Drinking Water Audit Report

County:	Mayo	Date of Audit:	23 February 2016
Plant(s) visited:	Swinford WTP	Date of issue of Audit Report:	7 March 2016
		File Reference:	DW2014/14
		Auditors:	Ms Derval Devaney Ms Michelle Roche
Audit Criteria:	<ul style="list-style-type: none"> • The <i>European Union (Drinking Water) Regulations 2014 (S.I. 122 of 2014)</i>. • The <i>EPA Handbook on the Implementation of the Regulations for Water Services Authorities for Public Water Supplies (ISBN: 978-1-84095-349-7)</i> • The recommendations specified in the <i>EPA Drinking Water Report</i>. • EPA Drinking Water Advice Notes No.s 1 to 15. • The recommendations in previous audit reports.

Photo 1 Rust on 1st contact tank

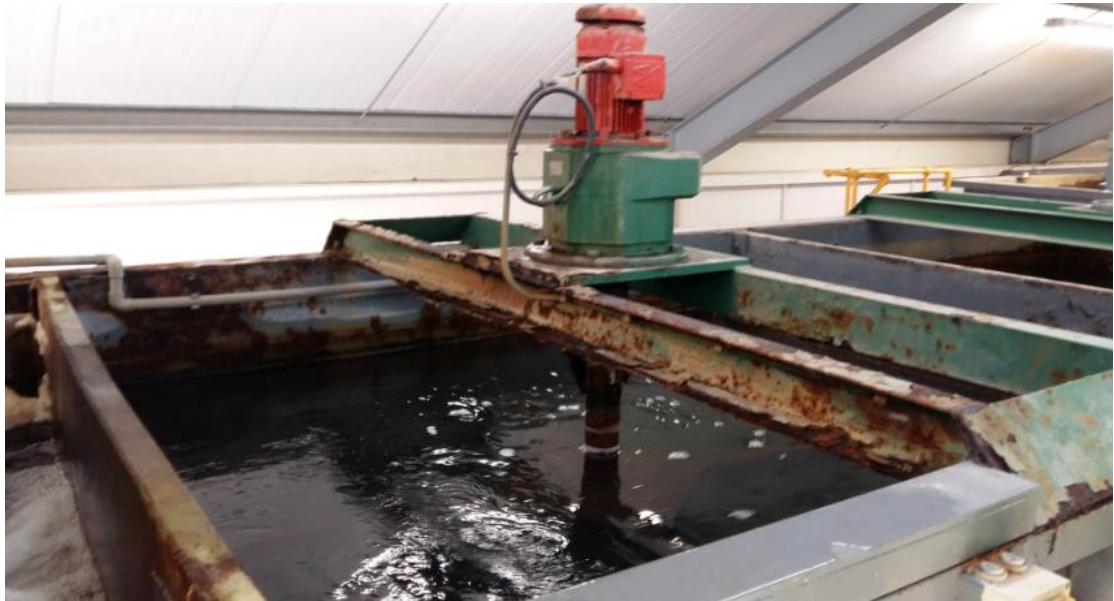
2.	<p>Coagulation, Flocculation and Clarification</p> <ol style="list-style-type: none"> The plant's design capacity is 75 m³/hr and the plant is currently operating at 55 m³/hr. The rising main is flow proportionally injected with PAC 10% prior to entry into the contact tanks. A flash mixer was installed on the raw water line to aid mixing. Water enters 2 baffled contact tanks - one has fast mixing and the other slow speed mixing to encourage floc formation. The first tank had rusted and was in need of maintenance (see Photo 1). The type of Poly used at the plant changed in June 2015 to a cationic material (Clear FLOC903P) and is added 20-30 minutes after the PAC at the end of the contact tank and prior to entry into a splitting chamber. The splitting chamber was installed 3 years ago to ensure the 2 No. DAFF units receive equal volumes of water from the contact tanks. There is no pH correction on the raw water. Optimum pH and aluminium dose for effective coagulation was not known. Chemical dosing is dependent on the raw water colour and turbidity concentration and such is displayed on a dosing chart (see Photo 2) which specifies dose concentrations. For example when raw water has a turbidity of 20-40 NTU and a colour of 20-40 Hazen, 100 mg/l of 10% PAC is added and 0.1 mg/l of Poly. Jar tests were last carried out on the supply in July 2015 and there is no facility on-site to carry out jar testing nor does the caretaker have the expertise to complete this test. The acrylamide concentration in the Poly dose was not known.

- (d) ensure the contact tank is inspected and maintained on a regular basis so that it is free from rust and structurally sound.
